UNITED STATES PATENT AND TRADEMARK OFFICE

10/666,319

Office Action Summary

DETAILED ACTION

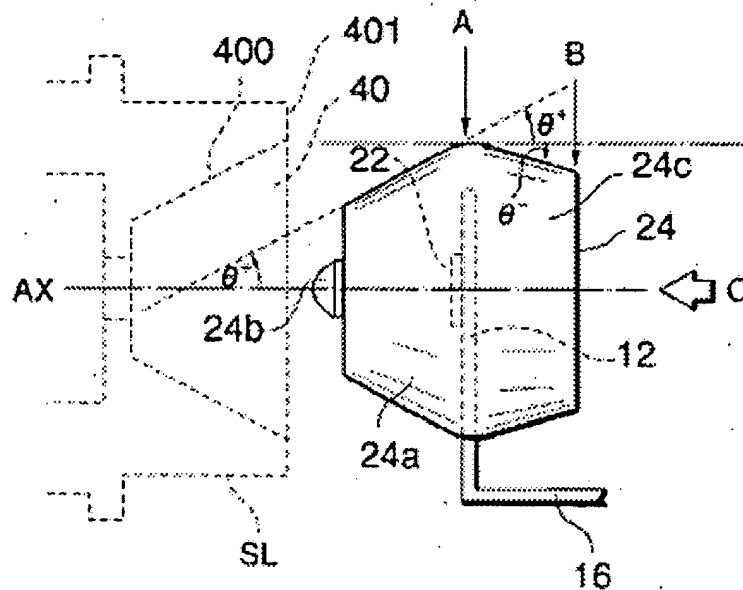
Regarding claim 1 Irie et al teach an optical assembly comprising a package including an optoelectronic component, an InGaAs laser diode (col. 7, line 29), an alignment feature mounted to a surface of the package (Fig. 4A, 24), a sleeve, wherein the alignment feature is inserted into the sleeve (Fig. 2, 8) and the sleeve is sized to mate with a ferrule of the fiber optic connector (col. 4, line 50-53).

Regarding claim 3, the alignment feature is a cylindrical post, not emphasized in reference but visible in Fig. 7A, the stepped features to the left of the three bore holes (h1, h2, h3). The

cylindrical post has a bore hole allowing the emitted light from the package to pass through (Fig. 4A, a long the AX line, Fig. 5C, the central hole). The bore hole allows the light emitting from the condensing lens, in a shape of a solid partial sphere (claim 5), to pass through.

In Fig. 4A, the particular embodiment shows that the base 24 fits snugly in the element SL thus the solid partial sphere 24b will make contact the inner surface of the sleeve.

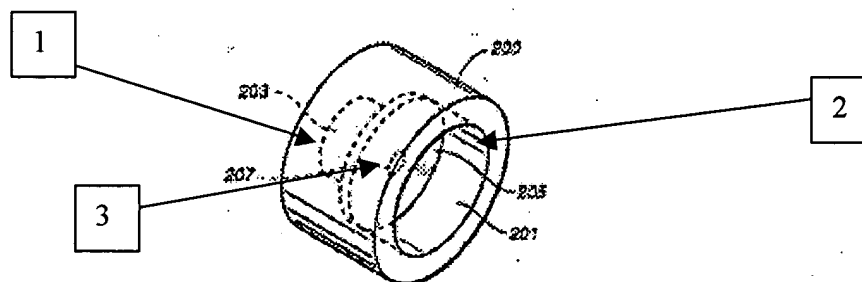
In Irie et al. invention, the head (24) is an optoelectronic chip enclosure. Furthermore, admitted by the Applicant in Fig. 18 (226) that TO can is known as prior art.

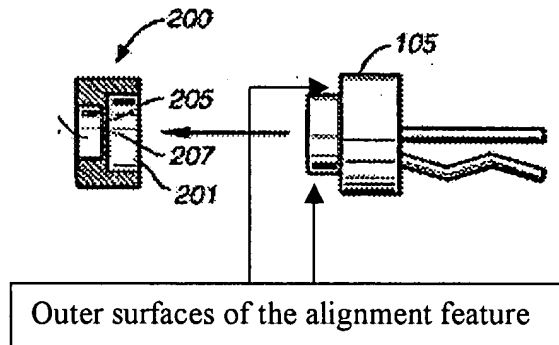
Freeman's connector element 200 has three inner diameters that are all constant. Due to the open-ended transitional recitation, Freeman's element 200 meets the limitation cited above.

--a constant inner diameter for receiving and contacting outer surfaces of the alignment feature--

The alignment feature is in how the pieces are fitted together along the optical axis and in this case the feature is how element 105 fits into element 200. Once fitted, the outer surface of the sleeve 105 and the surface that is perpendicular to the sleeve are in contact with the constant diameter 201 of element 200. Furthermore, Freeman teaches as prior art that it is well known to incorporate an ST connector into the assembly to couple emitted light from the laser diode to the ferrule (col. 1, line 14-17).
